OLT-specifiable Sync Pattern

Jeff Mandin
PMC-Sierra
802.3av TF Seoul meeting
Sept 2008

Overview of changes

OLT REGISTER State diagram (Fig 77-20)

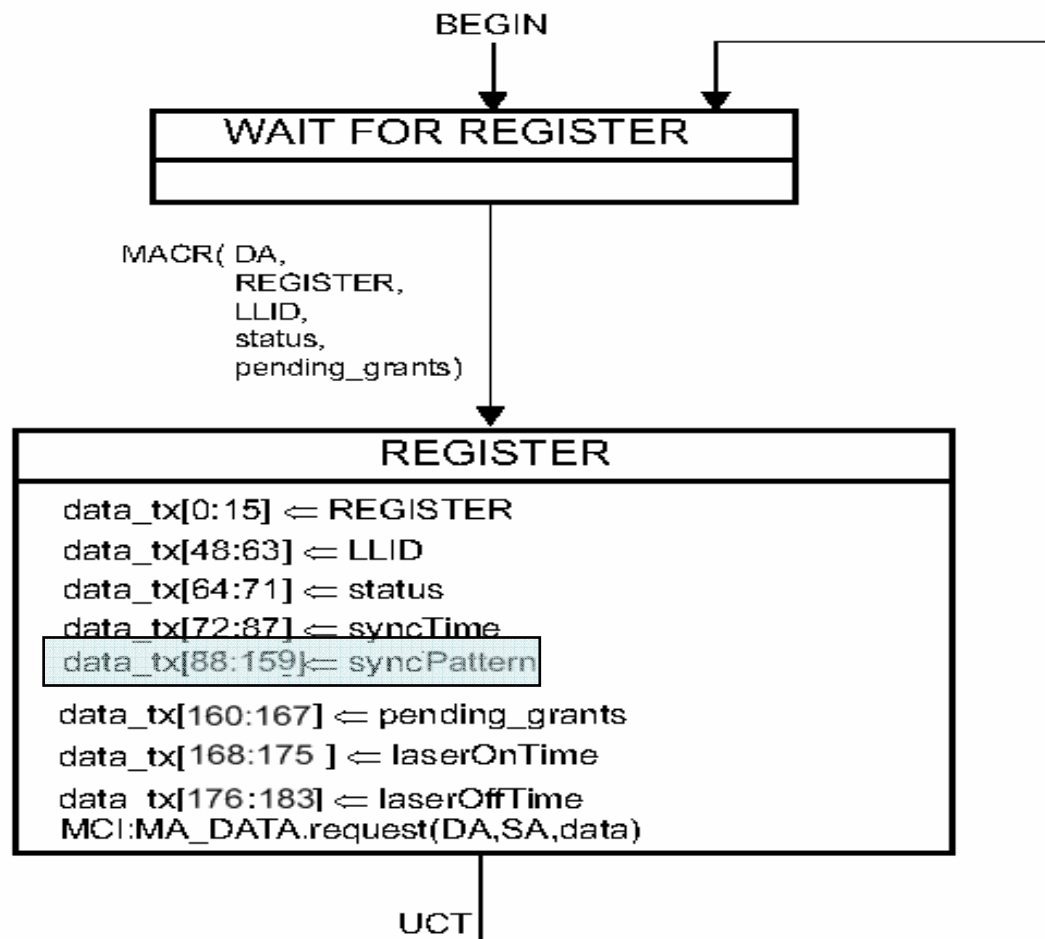
- syncPattern handling is based on handling for syncTime

ONU REGISTER State diagram (Fig 77-22)

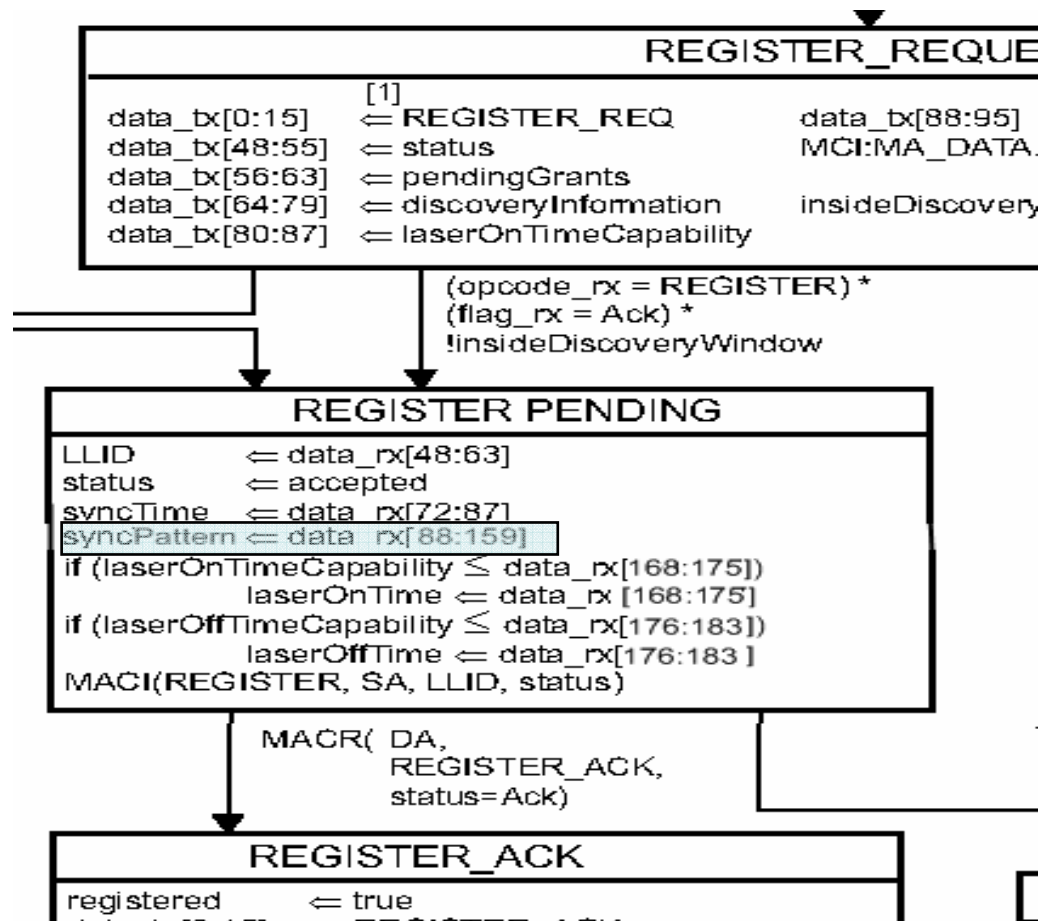
- syncPattern handling is based on handling for syncTime
